ADDENDUM OF SOLICITATION
INVITATION FOR BIDS (IFB No. 025-002)
ADDENDUM No. 1
Issued: November 22, 2024

Title: PRTC Ceiling Tile and Grid Removal and Replacement

- 1. PRE-BID ATTENDEE LIST, PRESENTATION AND ANSWERS TO SUBMITTED QUESTIONS –**
Providing pre-bid meeting attendee list, pre-bid presentation, and a matrix of answers to all submitted questions and attached herewith, **PRTC Ceiling Tile and Grid Removal and Replacement.**
- 2. Section III SCOPE OF WORK**
Revising Section III.4.G

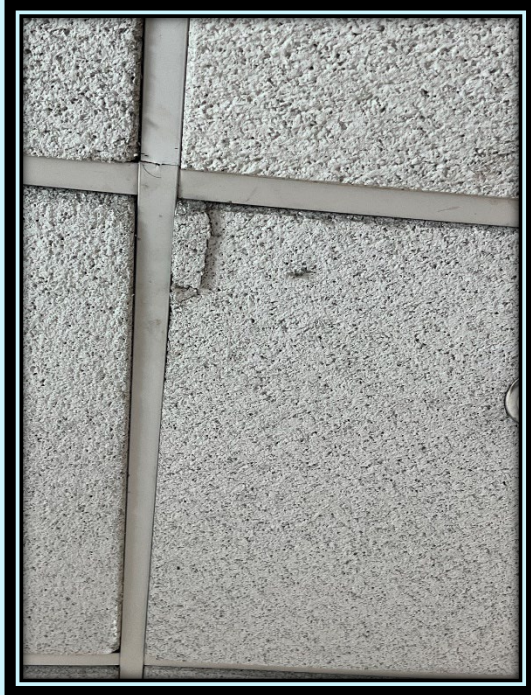
Ceiling Tiles are ill-fitted to the grid.

Ceiling tiles and grid are bowing.

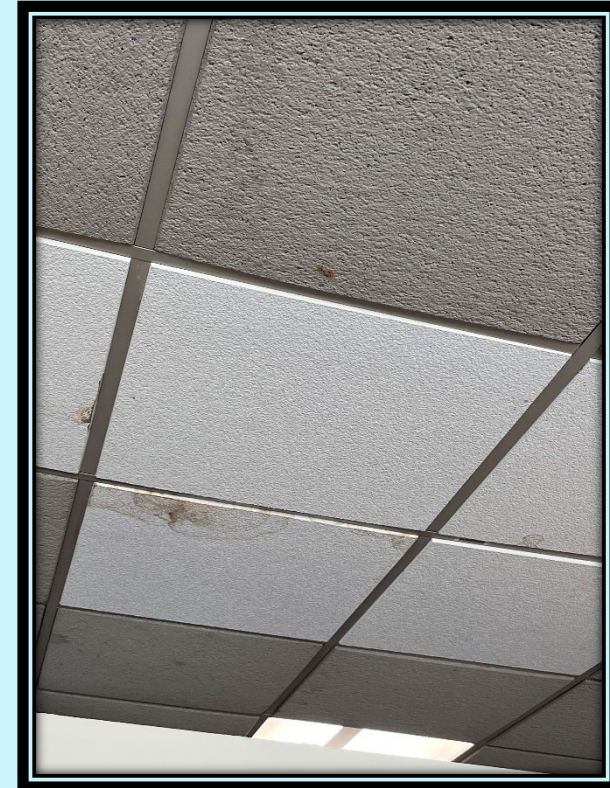
Ceiling tile and grid have been improperly repaired and adjusted.

Ceiling tiles are mismatched in color and show substantial staining.
